**WATER COMPANY 4,
NDI Pa-507.**

**PHASE I INSPECTION REPORT,
NATIONAL DAM INSPECTION PROGRAM.**

PHASE I REPORT
National Dam Inspection Program

PHASE I INSPECTION REPORT
NATIONAL DAM INSPECTION PROGRAM
CITIZEN'S WATER COMPANY DAM #4
NDI# PA-507, PENNDER# 63-3

PHOTOGRAPH 7 View of seepage emanating adjacent the spillway sidewall approximately 10 feet below the embankment bench level.

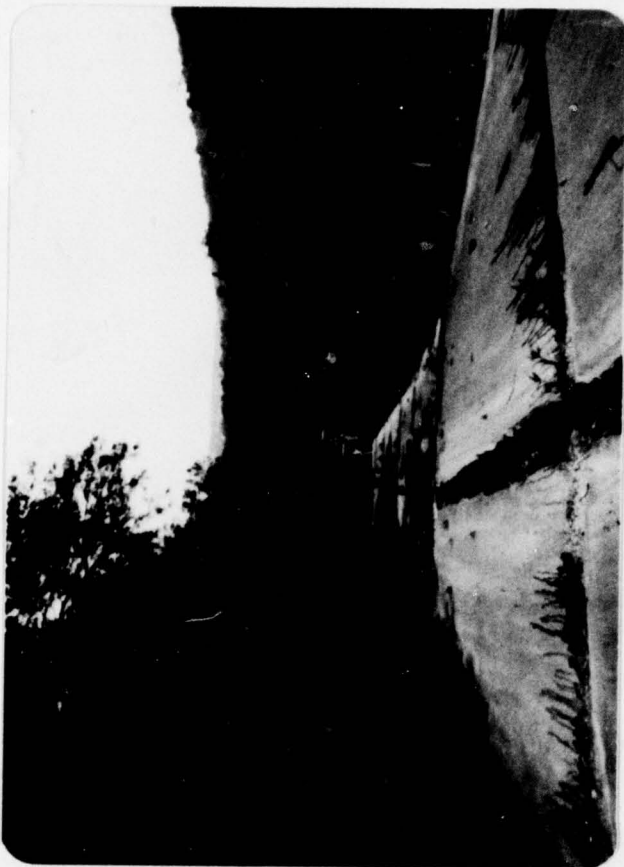
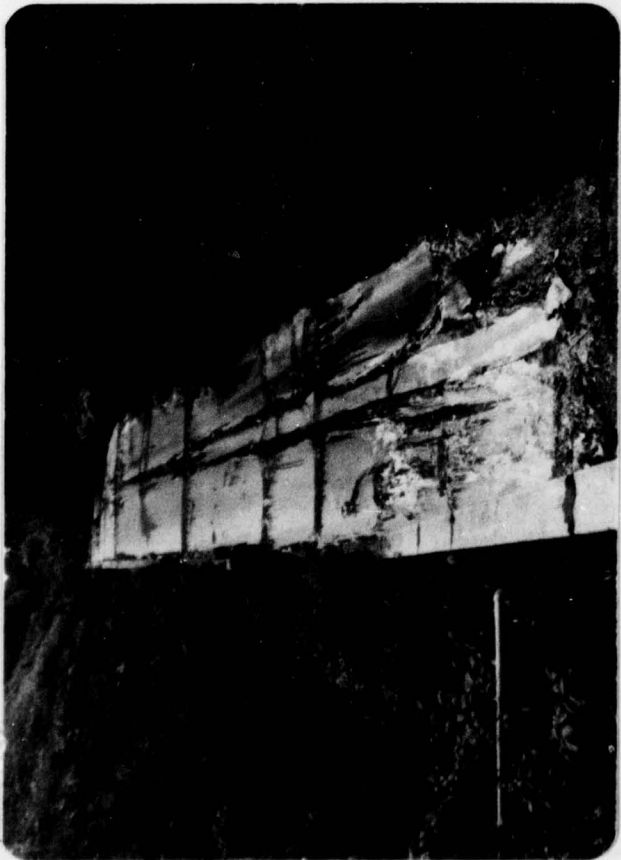
The lower third of the spillway chute has deteriorated and is in need of remedial maintenance. Seepage through and under the spillway near the embankment bench level should also be investigated and controlled.

1. Spillway. The upper two-thirds of the spillway including the wingwalls and channel floor appeared to be in fair to good condition. Joints and popouts have been sealed with bitumen. The bottom third of the spillway chute above the stilling basin is in poor condition with random spalling and severe scaling evident. Leakage through the left spillway wall appears to be causing some concrete deterioration. The ogee portion of the spillway and plunge pool walls appear to be in good condition (see Photographs 5 and 6).

a. the owner investigate and initiate remedial repair of the deteriorated spillway section. The investigation should include an assessment of the seepage source(s) within and adjacent the spillway with possible remedial schemes to direct the seepage through the underlying drainage system.
